Interconnection Facilities Study

GEN-2015-007/IFS-2015-001-01
GEN-2015-023/IFS-2015-001-08

July 2016

C : GEN-2015-023 Interconnection Customer Comments to Draft Report..... C-0

Figure 1 – Omitted Text – Breaker and a Half with 4 Positions

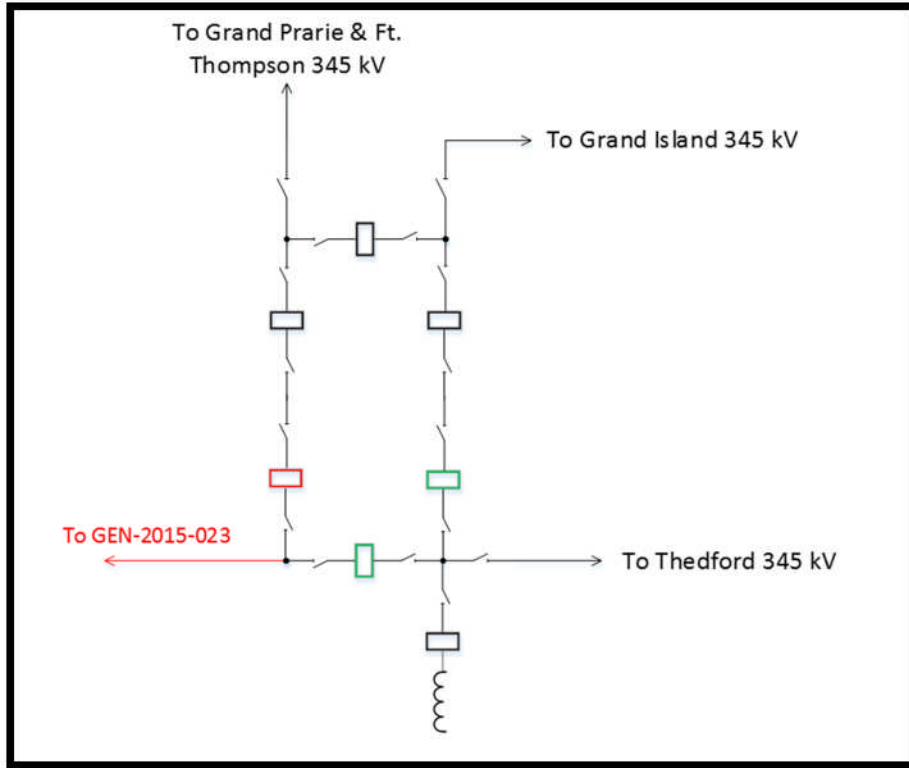
Omitted Text would like to propose the configuration shown in Figure 1 as an alternative to the NPPD proposed expansion of the Holt Substation in the Draft Facilities Studies for the interconnection of our GEN-2015-023 Project. NPPD's proposed expansion is shown on Figure 2
